## COUNCIL ASSESSMENT REPORT

### SYDNEY CENTRAL CITY PLANNING PANEL

<b>PANEL REFERENCE &amp; DA NUMBER</b>	PPSSCC-629 DA 856/2025/JP
<b>PROPOSAL</b>	Amending Development Application to an Approved Residential Flat Building Development (Under Development Application 846/2016/JP/A)
<b>ADDRESS</b>	Lot 122A DP 11104, 13 Terry Road Box Hill
<b>APPLICANT</b>	WSDC Box Hill Primitus Development Pty Ltd
<b>OWNER</b>	WSDC Box Hill Primitus Development Pty Ltd
<b>DA LODGEMENT DATE</b>	27 November 2024
<b>APPLICATION TYPE</b>	Development Application
<b>REGIONALLY SIGNIFICANT CRITERIA</b>	Clause 5(b), Schedule 6 of the SRD SEPP (Planning Systems) 2021
<b>CIV</b>	\$8,905,627.00 (excluding GST)
<b>CLAUSE 4.6 REQUESTS</b>	SEPP (Precincts – Central River City) 2021, Clause 4.3 Height of Buildings
<b>KEY SEPP/LEP</b>	<p>Section 4.15 (EP&amp;A Act) – Unsatisfactory.</p> <p>SEPP (Resilience and Hazards) 2021 – Satisfactory.</p> <p>SEPP (Biodiversity and Conservation) 2021 – Satisfactory.</p> <p>SEPP (Sustainable Buildings) 2022 – Unsatisfactory.</p> <p>SEPP (Precincts – Central River City) 2021 – Unsatisfactory.</p> <p>SEPP (Housing) 2021 – Unsatisfactory.</p> <p>SEPP (Transport and Infrastructure)

Figure 11 Height Blanket Diagram for Building A and B.

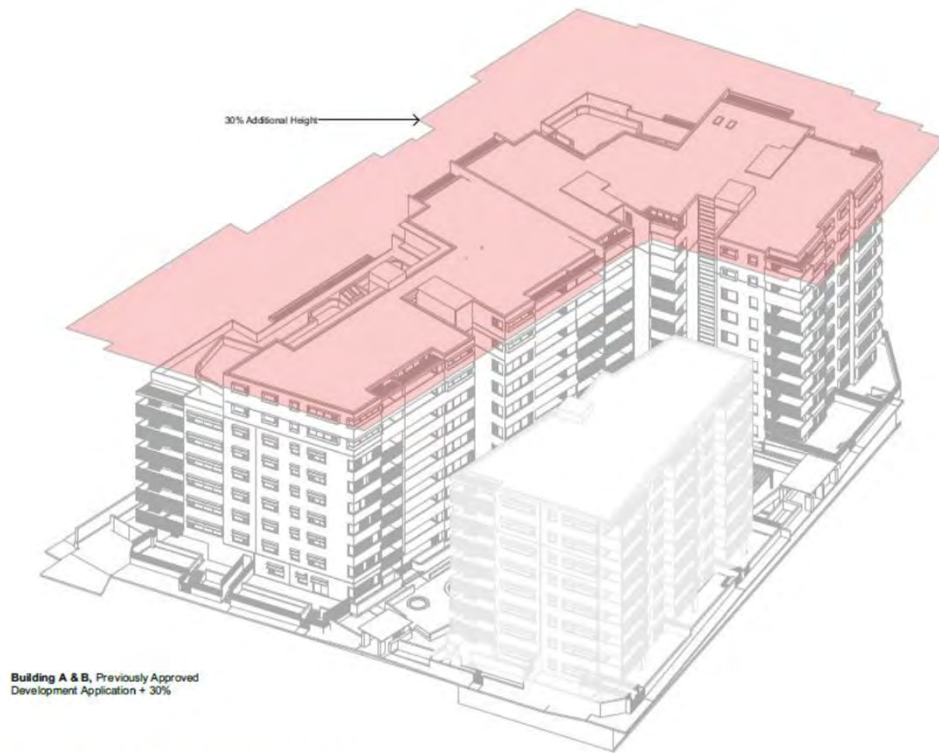
A Building Height Plane diagram which clearly illustrates the proposed developments’ height in relation to the maximum height permitted under the Housing SEPP based on the 21m height limit permitted under the Precincts SEPP, has not been provided to enable a full assessment of the proposed height variation. A building height plane diagram should clearly show the proposed height exceedance and indicate whether it also includes habitable floor space.

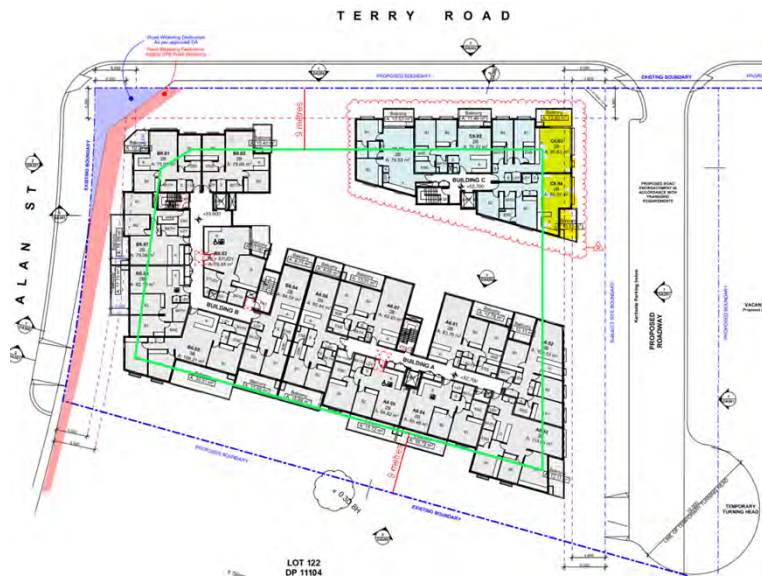
7% of the site area is required as deep soil, with minimum dimensions of 6m x 6m. Ideally for a site of this size, 15% should be deep soil. Plan DA730 indicates that an area of 483m<sup>2</sup> is provided as deep soil. Areas cannot be confirmed due to a lack of detail on the plan, including no scale. Furthermore, areas are included in the calculation, including substation, and street tree planting that should not be included. Minimum 6m x 6m dimensions are also not achieved. A reduction in deep soil is partly due to the expansion of the basement to accommodate the additional cars required for the additional units.

**Level 4-6 plan (9 metre separation required)**

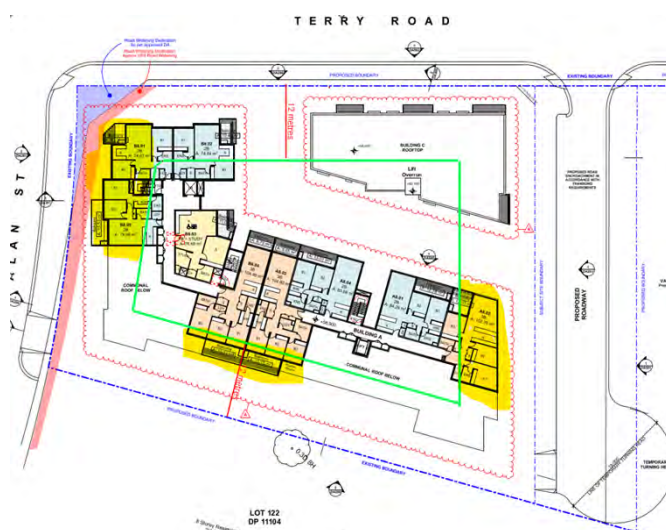
The plans do not provide setback dimensions to confirm compliance with the controls, however it appears that new levels proposed to Buildings A, B and C do not provide the required building separation as illustrated below, with encroachments highlighted in yellow.

DEEP SOIL SCHEDULE	
Area	
483.78

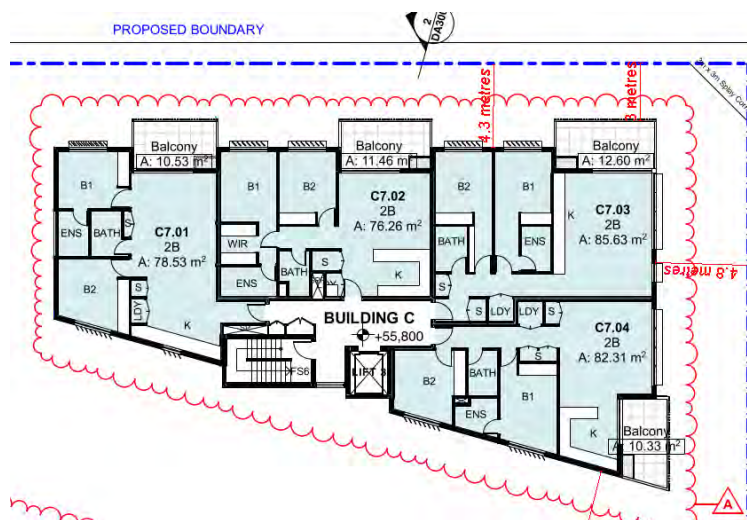
Approved modification 846/2016/JP/A landscaped area of was incorrectly calculated based on a site area which included the future road, and included roof top landscaping originally approved on Building C.

Landscaped area compliance cannot be confirmed since the areas shown to be included on the plan do not comply with the DCP definition of landscaped area. No scale is provided on the plan (DA730). Landscaped area and deep soil calculations are not separated on the plan. It is unclear if landscaped area within the road reserve has been included. The applicant has not provided sufficient information or justification to address the proposed landscaping on the site.

Approved Basement 1 (846/2016/JP/A)

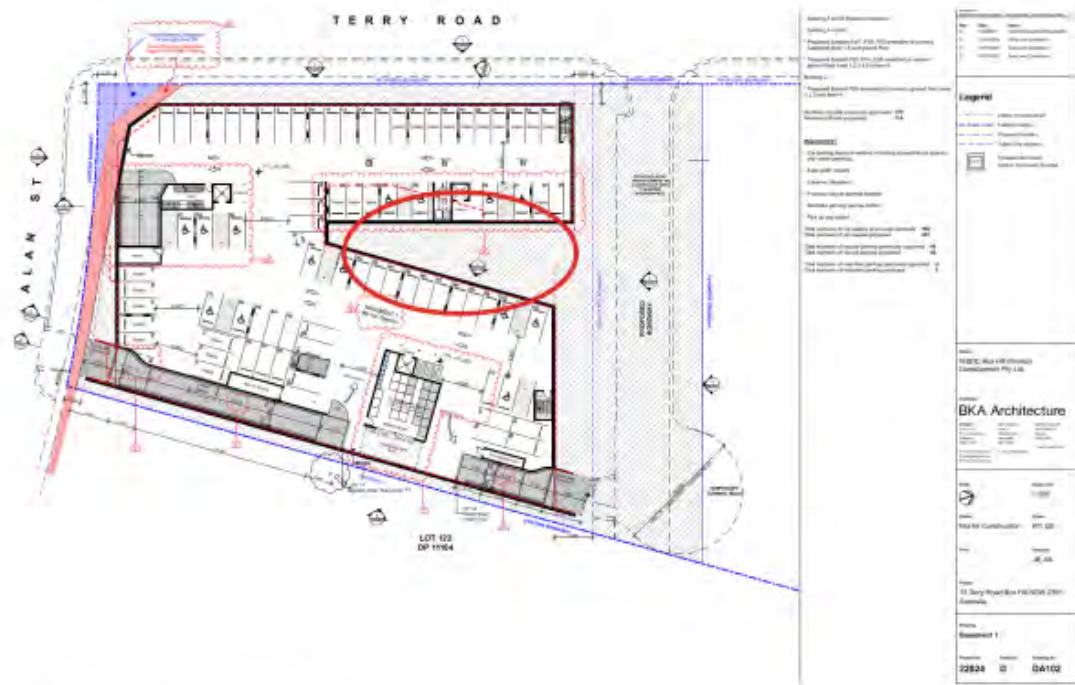
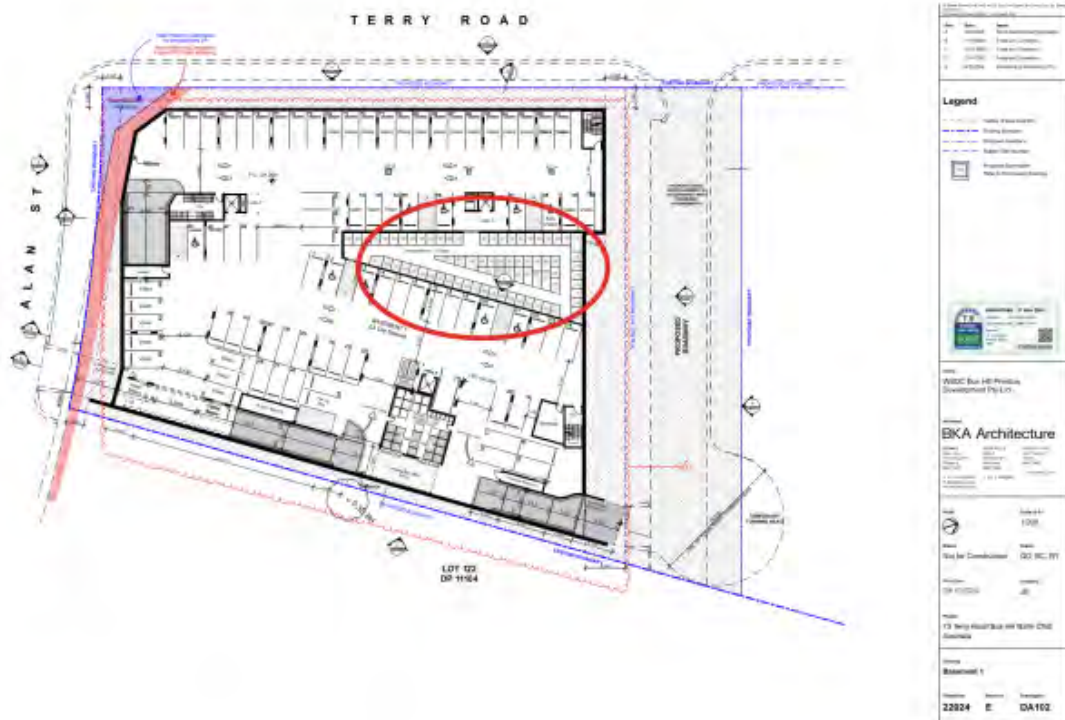
- c) According to the Housing SEPP definition of landscaped area, rooftop common open space cannot be included in the calculation.
- d) The proposed increased basement footprint (ie. compare approved and proposed Basement 1 plans) significantly reduces the potential for deep soil planting.
